## TRUCK GROUP

## SAFETY RECALL 05513

June 2005

Figure – Push Rod Location

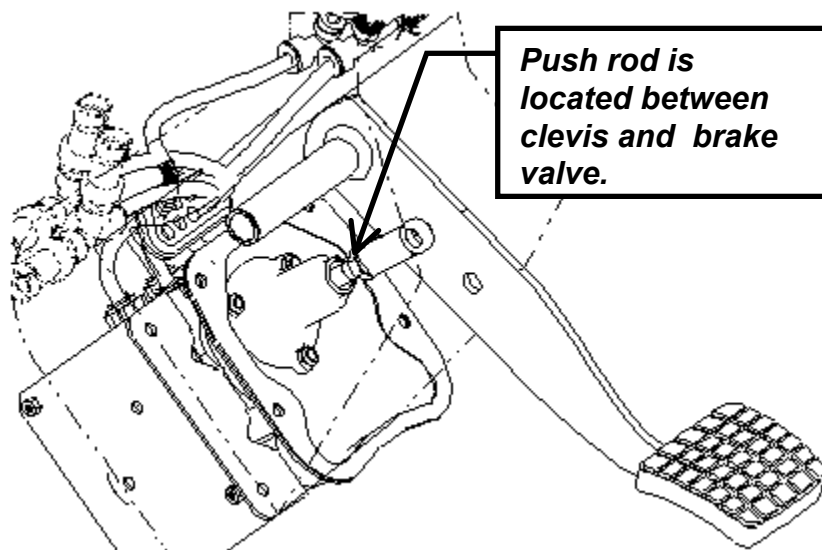
The push rod that connects the brake pedal to the brake valve was manufactured incorrectly and may break under certain loading conditions. See Figure.

If this push rod breaks while a vehicle is in operation, a partial loss of service braking may be experienced (although the park brake and if equipped, trailer hand control brake, are still operational). This could result in **a vehicle crash without warning** possibly resulting in **property damage, personal injury or death**.

2. **Please contact your local International dealer**, with your recall card in hand, to schedule an appointment to have your vehicle repaired.
3. Dealers will have parts and instructions to make an inspection or repair by **6/10/2005**. The inspection will be performed without charge to you and will take approximately **a half hour (0.5 hours)**.
